## **ITEM 2**

| <b>Application Reference</b> | <b>DC/073653</b>   |
| <b>PROPOSAL:</b>             | Conversion of existing building to form 12 no. apartments, additional fenestration, installation of dormers and roof lights, erection of an additional level to the stairwell, alterations to ground levels to east and improvements to the access road and associated infrastructure. |

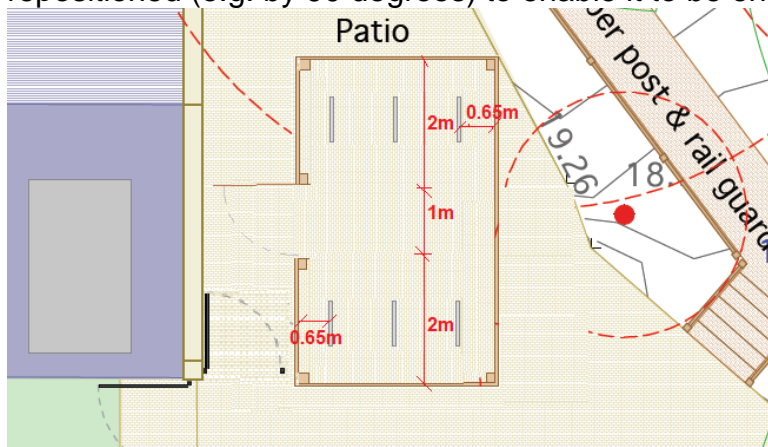
As such, I do not consider the reduced and revised access improvements are acceptable and therefore would be unable to support the scheme in its present form. I therefore recommend that the applicant reverts back to the previous scheme, or a scheme very similar (e.g. if the use of permeable surfacing would be cost-prohibitive, an alternative form of drainage, such as filter drains / swales, could be explored in collaboration with the LLFA). Consequently, the application will need to be deferred to allow this issue to be addressed.

Notwithstanding the need for the access improvements to be reviewed, a development of over 5 units would normally be required to be served by an adopted highway. As outlined in respect to the previous scheme, noting the site's constraints and the scale and nature of the development (all units are within a single building), subject to the upgraded access track being managed and maintained by a management company to ensure that it remains safe and practical to use, I would not object to the development being served by a private access road. This, however, can also be dealt with by condition.

## Site layout / detail

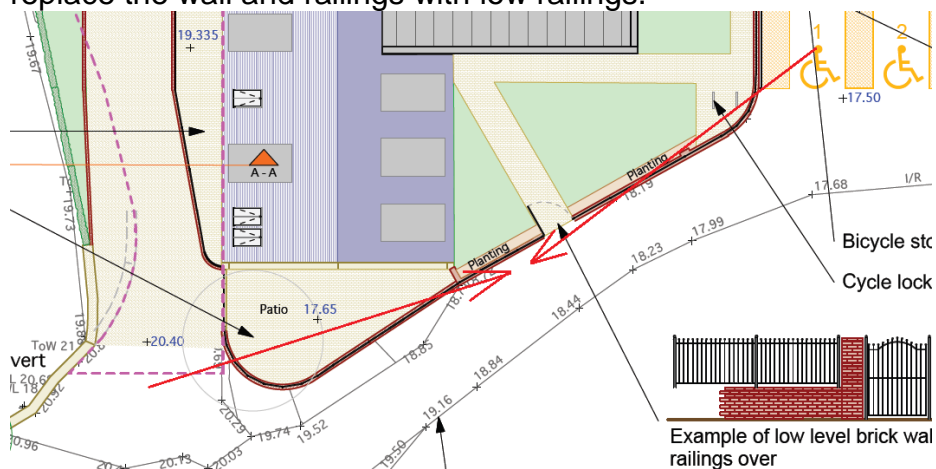
Whilst I consider the site layout generally acceptable, the railings to be erected on top of the proposed wall along the site's frontage with the access track would compromise visibility at the adjacent accesses, as shown on the plan below. The boundary treatment therefore needs to be amended to address this issue. I have discussed the matter with the Council's Conservation Officer who has confirmed that the erection of low railings (similar to those along the access road to the car park) is preferred from a conservation perspective. This would be acceptable from a visibility perspective and therefore I would recommend that the scheme is amended to replace the wall and railings with low railings.

With respect to pedestrian access to the building, a 1.2m wide path is proposed to be provided between the car park and the front of the building where the entrance to the building will be located. Whilst this is a narrower than is ideal and will have steps, as this will not need to be used by disabled persons, I would not object to this,

subject to the path being illuminated at night and handrails being provided. This could be dealt with by condition.

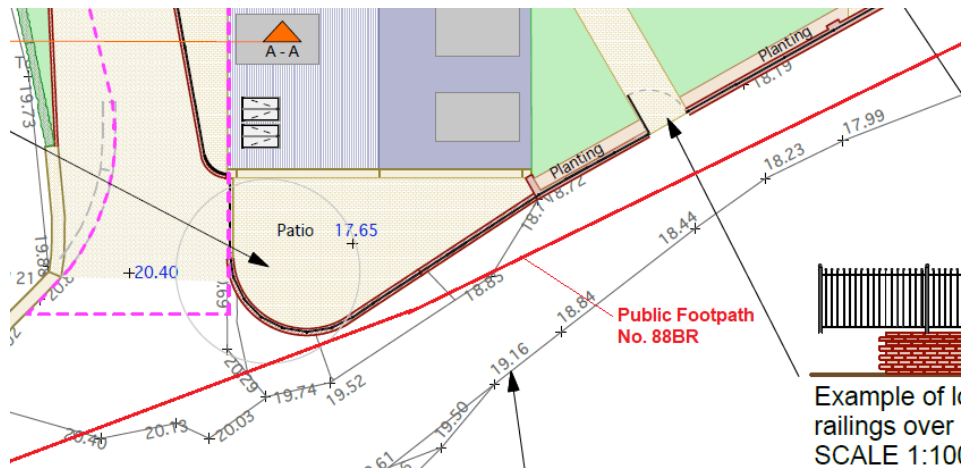
A public right of way (footpath 88BR) runs along the access track adjacent to the site, with the centre line of the recorded route passing within 300mm of the proposed site boundary (as shown on the plan below). Noting that the track is around 3-4m wide, if it is considered that the legal width of the right of way is the same, then the site will encroach onto the right of way. If this is the case, the scheme will need to be amended so that the public right of way is not affected or the right of way will need to be diverted. I would therefore recommend that this issue is brought to the applicant's attention and a solution is agreed with the Council's Public Rights of Way Officer.

Finally with respect to the access drive that will serve the site's car park, whilst I consider the width acceptable, it would appear that some of the works to raise the land to the east side of the drive (i.e. that to the east of the hedge) may be outside the site edged red. This therefore needs to be reviewed, as does the site edged red, in general, as it does not cover the whole access track (to Mill Pool Close). Notwithstanding this, details of the retaining structure that will retain the access road and car park will need to be agreed. This, together with other matters of detail design, however, can be dealt with by condition.
